Los Angeles County
Metropolitan
Transportation
Authority

TO: MTA BOARD OF DIRECTORS
FROM: STANLEY G. PHERNAMBUCQ *[Signature]*
SUBJECT: MTA CONSTRUCTION NONCONFORMANCE REPORTS

Attached please find copies of the Nonconformance Reports (NCRs) received by the MTA Director of Quality Management for the week of October 7 - 19, 1995.

Sketches:

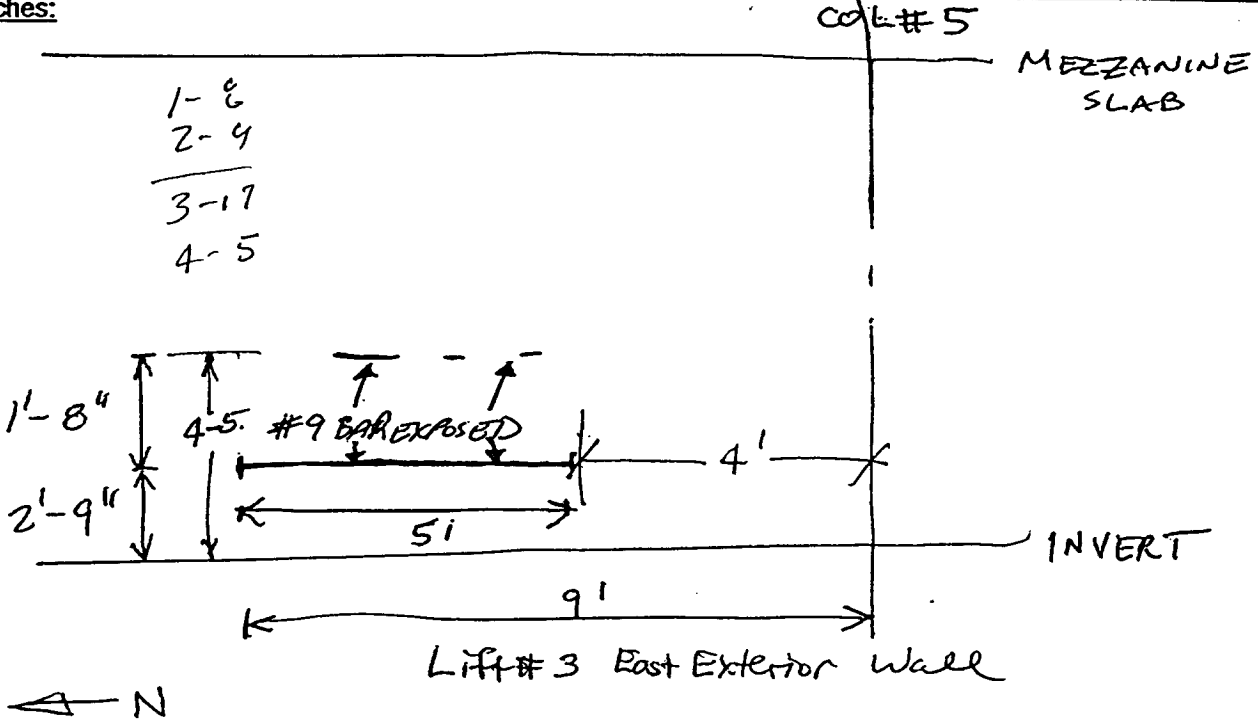
7. B-241 Specification No.: 03200.3.3.A, 03200.3.3.E.1.c.			8. Originator: Robert Kapchan		Phone No.: (213)644-1986	Hold Tag No. NA
9. Contract Requirements: The contractor is required to arrange and place reinforcing as indicated on the approved drawings and as specified in ACI 117. Non-conformance: After stripping form work for Exterior Wall No. 3-E, it was noticed that #9 horizontal rebar was exposed at the bottom of the flute of the architectural finish at 2'-9" and at 4'-5" above the invert for about five linear feet. These flutes are about 7/8" deep. (SEE ATTACHED SKETCH).

Upon stripping formwork from Lift # 3 E, it was noticed that # 9 horizontal rebar was exposed @ surface of exterior wall along 2 bars.

See sketch above.
